# UNITED STATES PATENT AND TRADEMARK OFFICE

10/533,990

<b>Office Action Summary</b>	<b>Application No.</b> 10/533,990	<b>Applicant(s)</b> WUNDERLICH, ANDREAS	
	<b>Examiner</b> David C. Reese	<b>Art Unit</b> 3677

## **DETAILED ACTION**

EP 0 501 860 A1

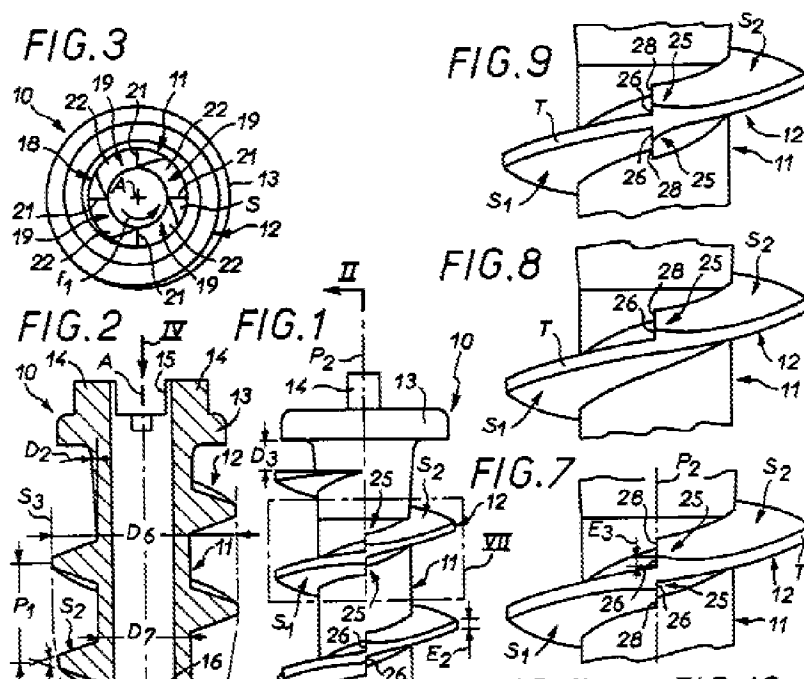
Examiner is very unsure of what is being claimed, but as best understood, Auger teaches in the Figures and abstract a screw capable for use on hard materials, with a shaft, head at one end, tip, and a thread with cutting teeth having equal but opposite sides that are laterally offset to opposite sides of the thread's longitudinal centerline. (see new matter above). There are a series of cutting teeth formed along at least one half turn of the thread—the series is formed by considering multiple half turns to include multiple teeth. As best understood, noting that paragraph [0008] is the only disclosure of a sawtooth, examiner considers Auger Fig 1 to be a sawtooth profile, with teeth disposed to opposite sides of the longitudinal centerline (see new matter above).

The thread has a flattened crest forming a narrow face (T) with edges 28 extending across it, and there are a plurality of narrow faces along at least one half turn – the plurality is along several turns, which are at least one half turn, and there are cutting edges. The transverse leading edges on at least one side are roughly radially disposed and extend all the way down to the shaft (Fig 10, and Fig 6, not copied, best shows this). The thread has the alternating offset of the cutting teeth providing alternating protrusions and notches along sides of the threads (Figures, esp. 8,5,10) The teeth are along a longitudinal centerline of the thread and have leading edges as

described, and the figures show cutting teeth edges disposed along radii all the way down to the screw shaft. (Figures). The included angle between sides S1 and S2 of the thread are in a range of 20-30 degrees at the portion due to penetrate the drilled hole wall. The included angle between sides S1 and S2 of the thread are in a range of 45 to 60 degrees over the transition zone immediately adjoining the shaft. Fig 7 and 8 show the teeth (on upper vs lower sides) offset from one another by the width of their face. The set of teeth vary over the shaft length- some are on one side, some are on the other, some have "double" teeth (fig 9 and 7), which is varied.
